JOANN LELECK ELEMENTARY SCHOOL AT BROAD ACRES, MANDATORY REFERRAL NO. MR2024007 & FINAL FOREST CONSERVATION PLAN NO. F20240370

Mandatory Referral review for the replacement of the existing Joann Leleck Elementary School with a new school building and associated site features.

No. MR 2024007

Completed: March 11, 2024

Figure 8: Proposed Access and Circulation

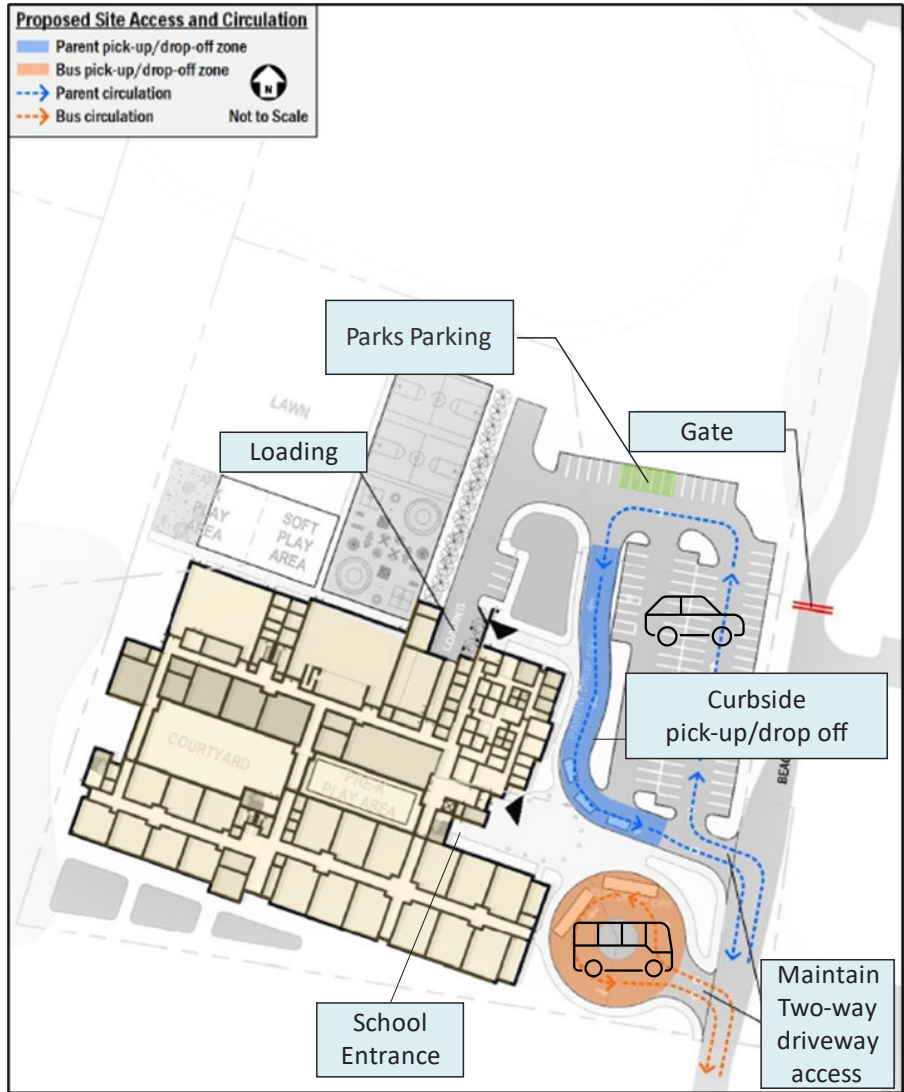
Staff notes that Section 59.6.1.4.D of the County Code, allows for a maximum of two driveways for every 300 feet of frontage along any street. Mandatory Referral Applications are not subject to the Zoning Code, but it is important to note that the intent of this requirement is to increase safety of all travel modes as it reduces conflict points on-site. However, separating bus and passenger vehicle access is a noted best practice for school site design as it reduces potential exposure between buses and cars and yields an improvement in safety and efficiency of all transportation modes and is therefore in the public interest. In this case, removing all existing parking spaces from the existing bus loop, with the objective to separate buses from passenger vehicles the main entrance of the Site increases the safety and efficiency of the Site access and circulation.

2. The Applicant should continue the sidewalk grade, material, and cross slopes across the two driveways.
3. The Applicant should comply with the approval conditions for Forest Conservation Plan F20240370.

4. Parking
 - a. The Applicant should provide no more than 116 vehicular parking spaces for faculty, visitors, and staff.
 - b. The Applicant should continue to provide five (5) reserved vehicle parking spaces for Broadacres Local Park patrons.

- c. The Applicant should provide 40 short-term bicycle parking spaces, located near the main entrance to the new school.
 - d. The Applicant should explore options for permeable pavement within parking bays.

Figure 9: Proposed Specimen Tree Removal and Mitigation Planting

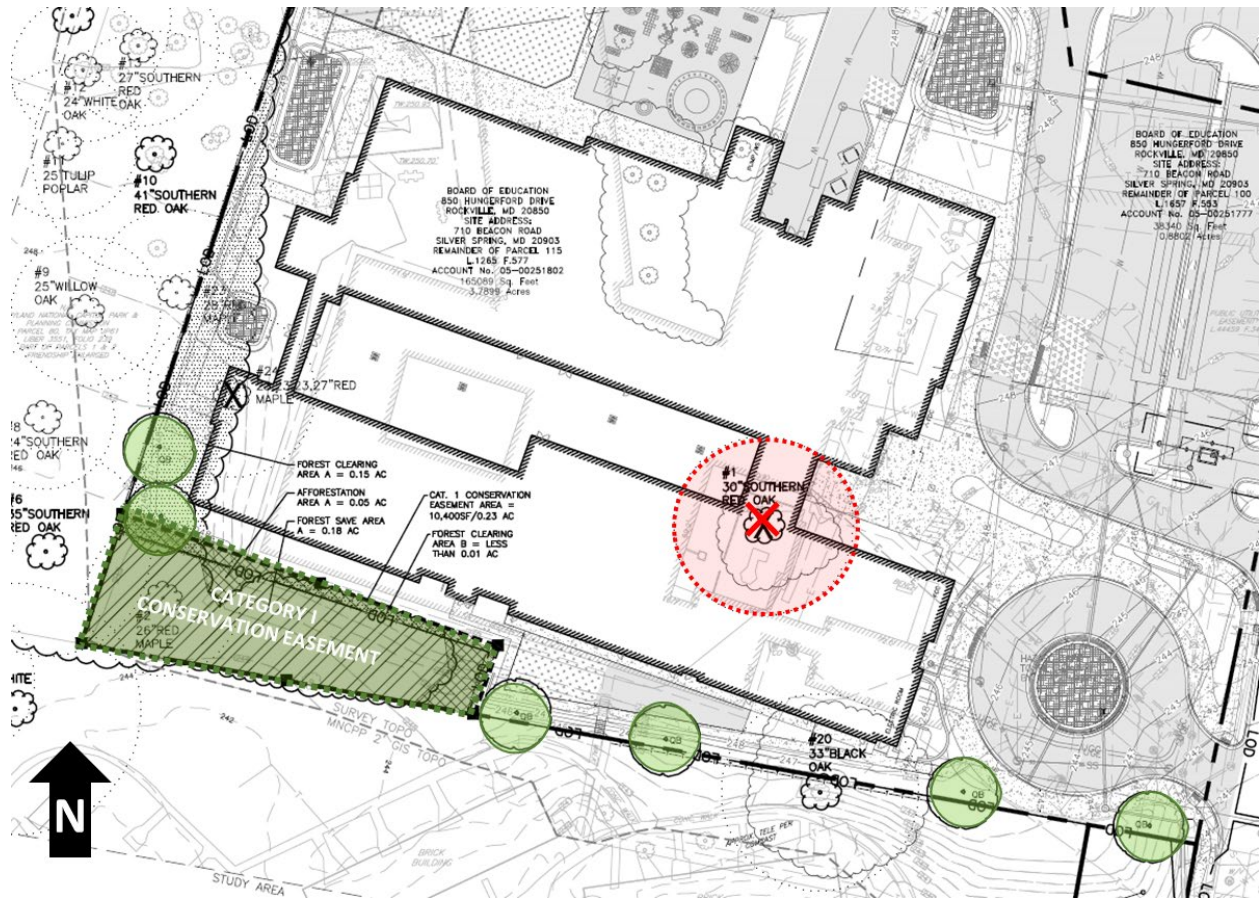
In addition to the high-priority forest area, there are four specimen trees proposed to be impacted by the Proposal, which are subject to a Forest Conservation variance, as detailed in Section 5 of this report.

There is one Protected Tree proposed for removal in this variance request, resulting in a total of 30 inches of DBH being removed. The Applicant proposes mitigation at a rate that approximates the form and function of the tree removed. The tree will be replaced at a ratio of approximately 1-inch caliper for every four inches removed using trees that are a minimum of three caliper inches in size. The removal necessitates mitigation in the form of tree plantings, totaling 8 caliper inches, to be installed on the property. However, the Applicant is proposing to exceed the mitigation requirement by planting six trees, each with a caliper of 3 inches. These trees will be overstory trees native to the Piedmont Region of Maryland and will be planted on the property, outside of any rights-of-way and utility easements. The locations of these plantings must be shown on the certified Final Forest Conservation Plan.

1. Before certification of the Final Forest Conservation Plan, the Applicant must update the plan per the following:
 - a. Update all FCP sheets for consistency regarding tree removals, variance tables, mitigation and supplemental plantings, and associated plan elements as shown in the staff report and/or approved by the Planning Board.

- e. Work with an ISA Certified Arborist who is also a Maryland Licensed Tree Care Expert to implement the tree-save plan, which includes protective measures for Trees #20 and #23. Additionally, an appropriate tree care professional will implement a five-year tree care program to ensure the long-term maintenance and monitoring of the prominently featured specimen Tree #20.
